Friends of Centurion Way.

FOCW is committed to ensuring that CW remains a safe connected route from Chichester to the Downs and the routing along Westgate is therefore vital for commuting, leisure and vulnerable cyclists and walkers. We would like you to consider the following comments and objections to Traffic Regulation Order (TRO) CHS9038RC.

(vi) install a flat top hump on Westgate Link Road 28 metres south of the Westgate roundabout junction to provide an uncontrolled pedestrian crossing point.

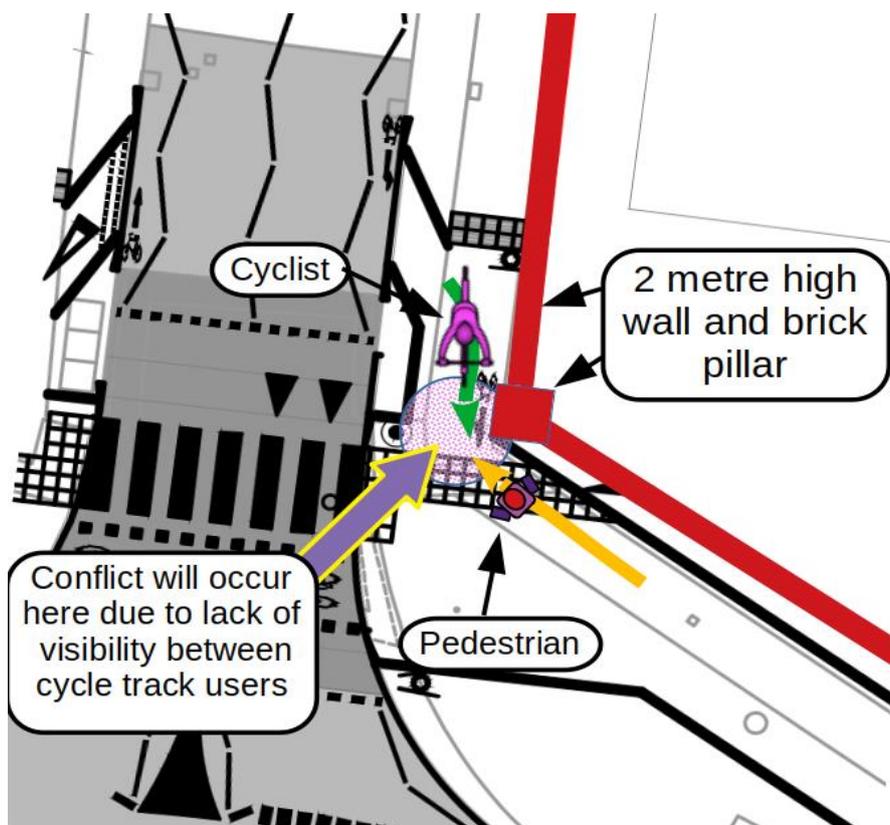
FoCW recommend the following item **should be improved** by changing the crossing type on the hump to a parallel controlled crossing as described in section 17 of the DfT Traffic Signs Manual Chapter 6.

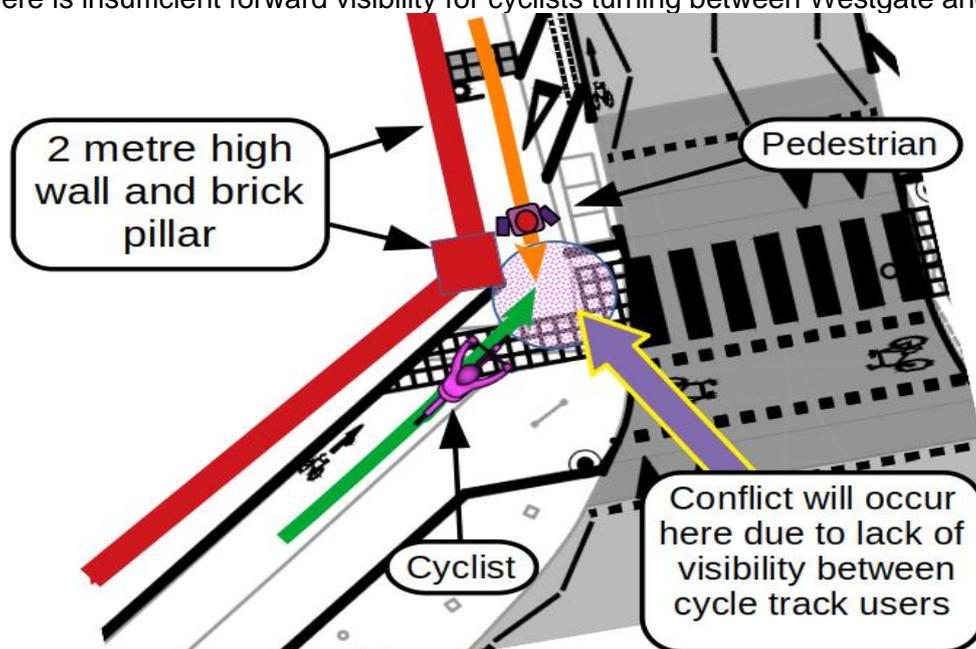
(1). There is insufficient forward visibility for cyclists turning between Sherborne Rd and Westgate. This is a safety issue as cyclists are likely to collide with pedestrians at the blind corner.

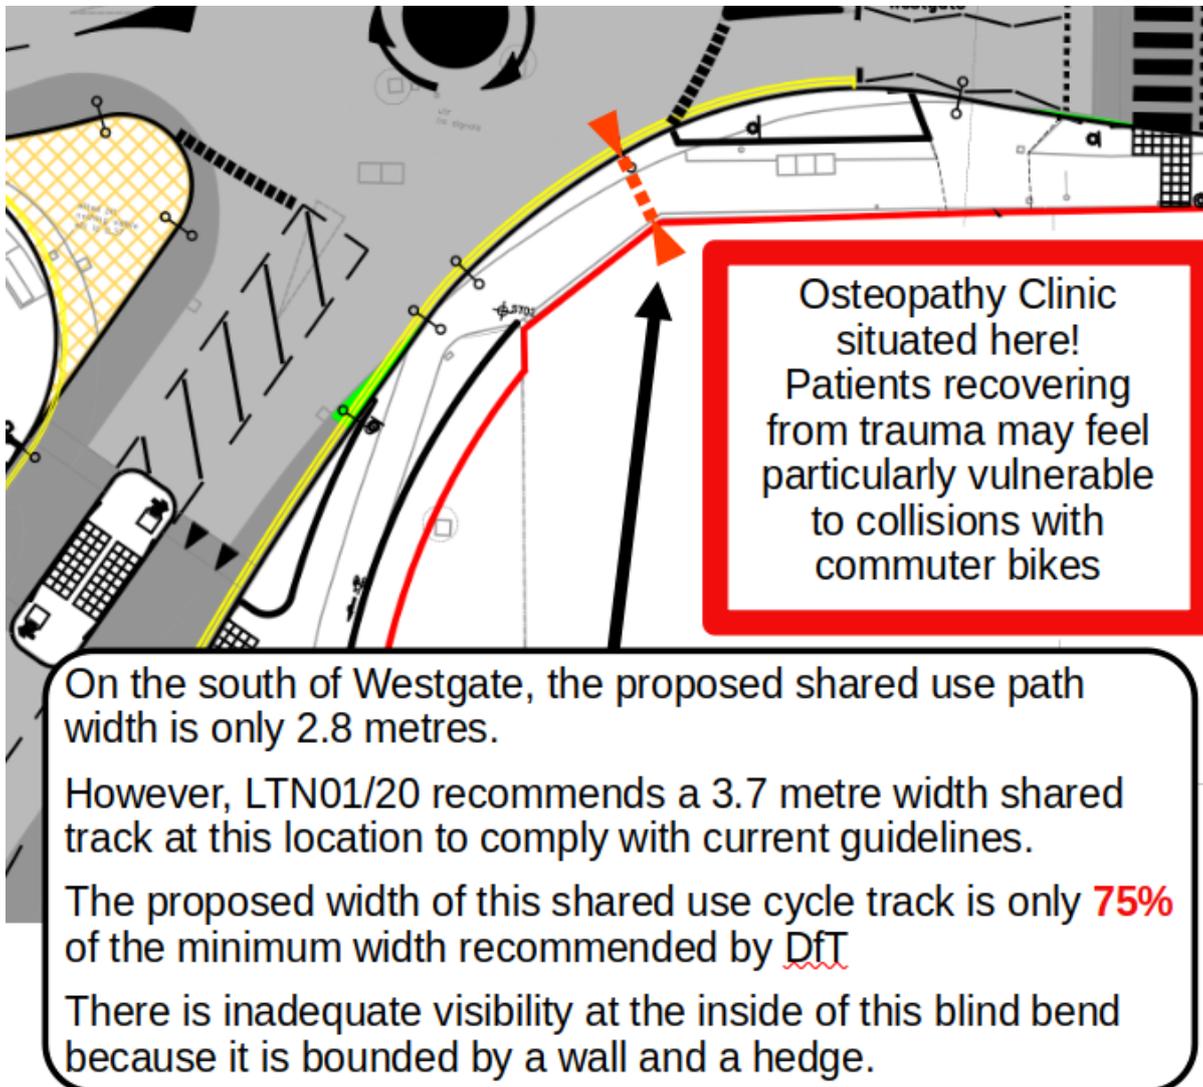
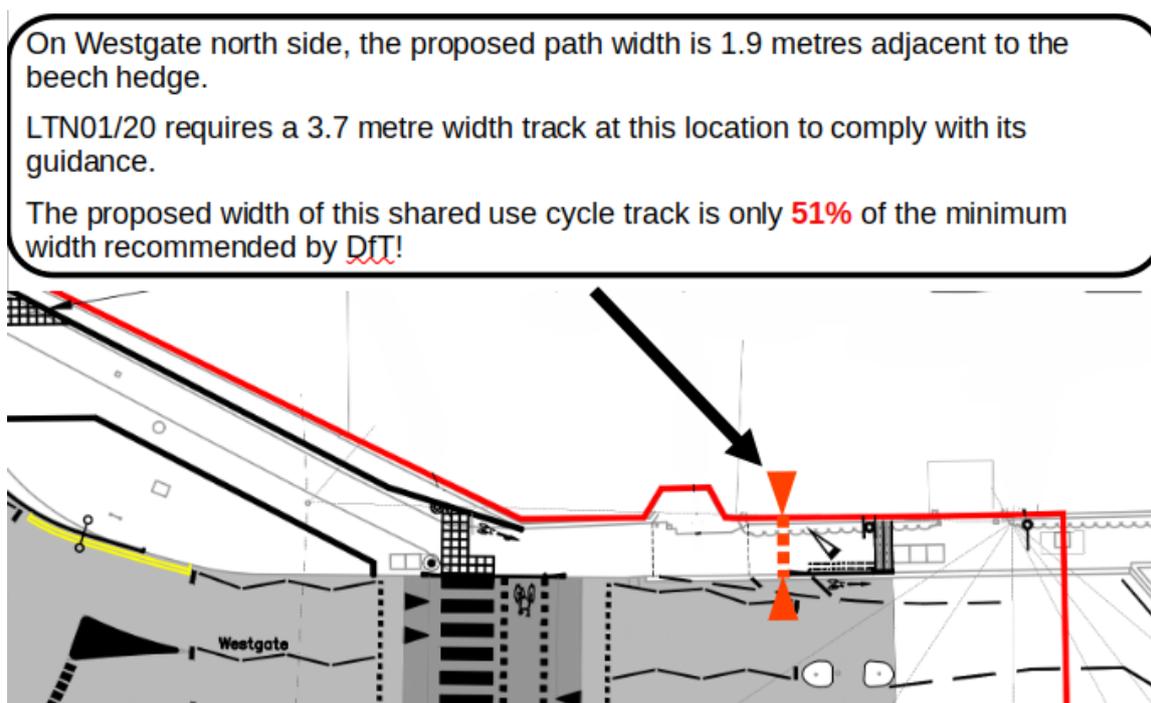
(3). On the South-East quadrant of the Westgate roundabout, two way cycle traffic will be directed onto a shared use cycle track running on a narrow pavement. This creates a blind bend where cyclists and pedestrians are likely to collide. The issue is compounded by vehicles leaving and entering a blind access way to a busy osteopathy clinic (No 107 Westgate). At this location the shared use cycle track has inadequate width for cycles to turn 90 degrees onto the parallel crossing. To enable cyclists to safely turn onto the parallel crossing a Jug Handel arrangement would be needed as described in LTN1/20 section 9.3.4

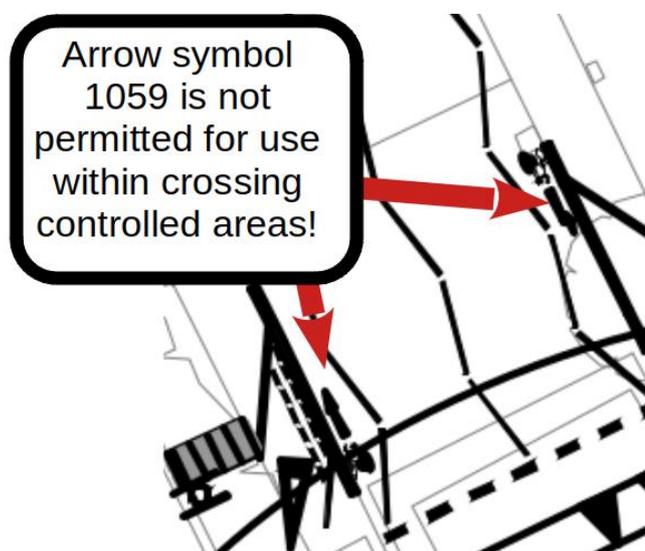
(6). Inappropriate road markings are proposed within the parallel crossing control areas. DfT Traffic Signs Manual Chapter 6 section states:

*15.8.16. Markings to diagrams 1029 (S11-4-18) and 1062 (S11-4-33) may be used at or near a crossing. The use of diagram 1062 is described in Chapter 5.*

**15.8.17. No other marking may be used within the controlled area**, except hatched and chevron markings in the circumstances described in 15.8.4 and the cycle symbol to diagram 1057 where the zig-zags are off-set from the kerb to allow cycling.

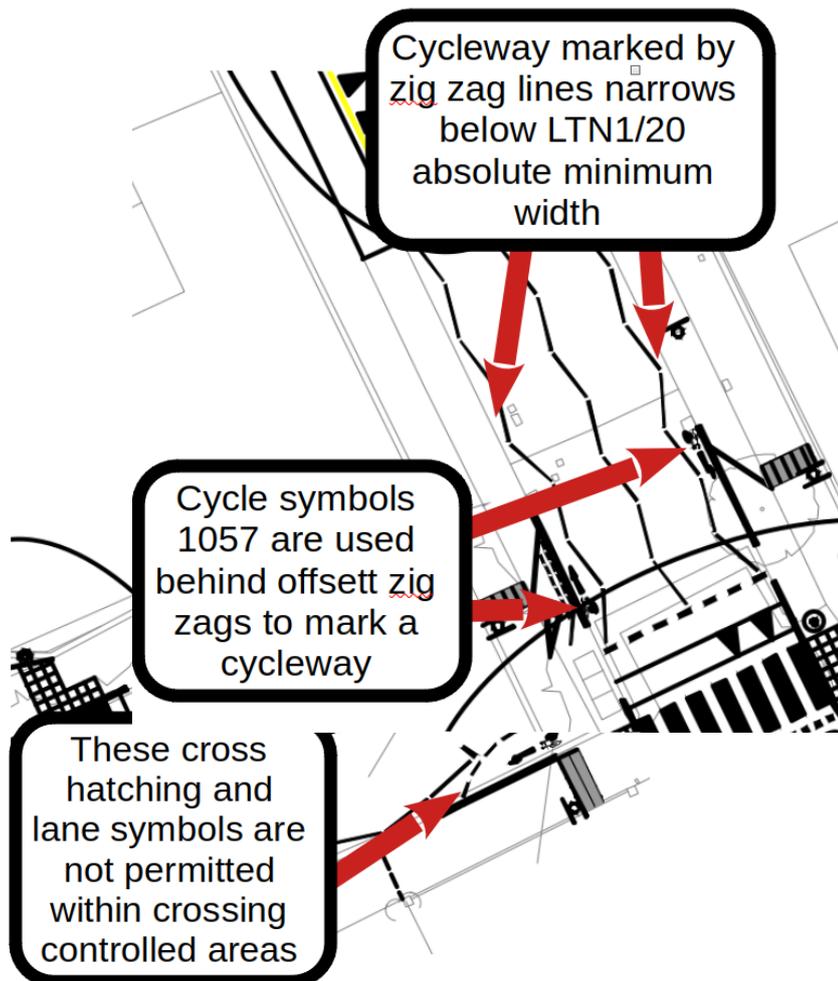
Hatched, chevron or edge of carriageway markings are not permitted between the outside carriageway kerbs and the outer zig zag lines that mark out crossing controlled areas. Please see DfT Traffic Signs Manual Chapter 6 section 15.8.4.
